# MARKED-UP CLAIMS ACCOMPANYING RESPONSE TO OFFICE ACTION FOR USSN 09/457,434:

MARKED-UP PAGES 8 AND 9 OF THE SPECIFICATION SHOWING CHANGES MADE ACCOMPANYING RESPONSE TO OFFICE ACTION FOR USSN 09/457,434

REPLACEMENT PAGES 8 AND 9 OF THE SPECIFICATION ACCOMPANYING RESPONSE TO OFFICE ACTION FOR USSN 09/457,434

Marked-up Figure Showing Changes made Accompanying Response to Office Action For USSN 09/457,434

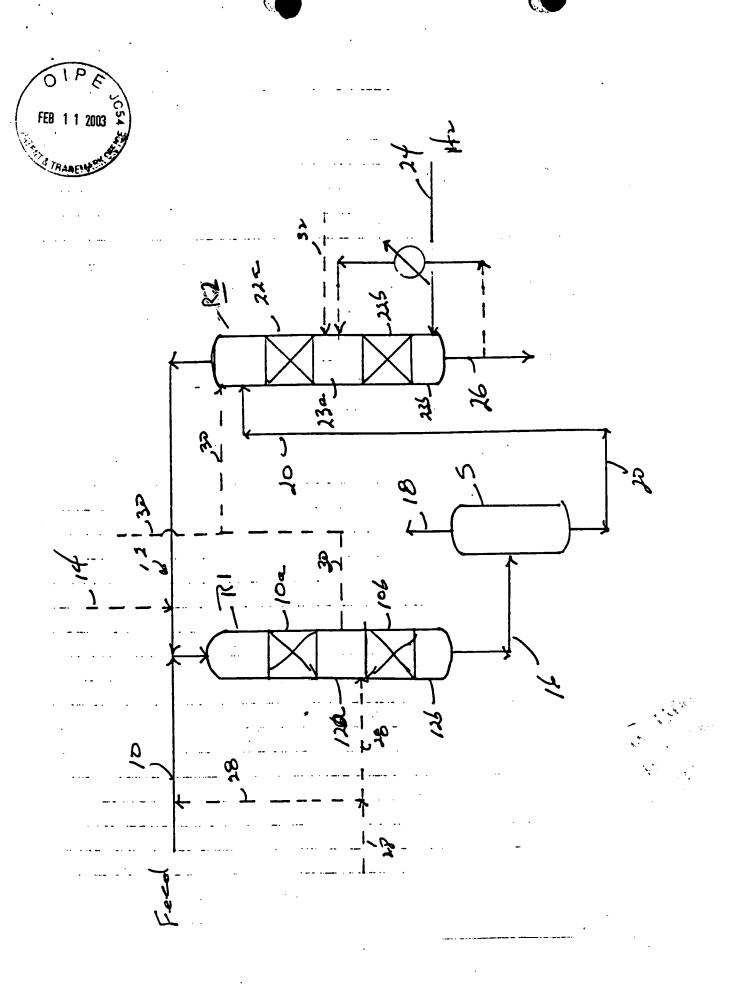
The Figure corresponding to the instant specification has also been amended according to the Examiner's suggestions. Namely, the reference number "R2" has been added to refer to the second reaction stage. No New matter was added.

The Examiner points out that the specification on page 8 teaches that the vapor product stream is collected via overhead line 20 when the drawing gives this line

reference numeral "18". The Examiner also points out typographical errors in the specification.

Page 8 of the specification has been amended according to the Examiner's suggestions. Namely, the second "is" as it appears in the last full sentence of page 8 has been deleted. Also, the reference to the overhead vapor product stream as line "20" has been amended to refer to this stream with reference numeral "18"; this overhead vapor product stream is denoted as such in the attached Figure. No New matter was added.

A combined liquid phase and vapor phase product stream exit reaction vessel R1 via line 16 and into separation zone S wherein a liquid phase product stream is separated from a vapor phase product stream. The liquid phase product stream will typically be one that has components boiling in the range from about 150°C to about 650°C, but will not have a boiling range greater than the feedstream. The vapor phase product stream is collected overhead via line 18.
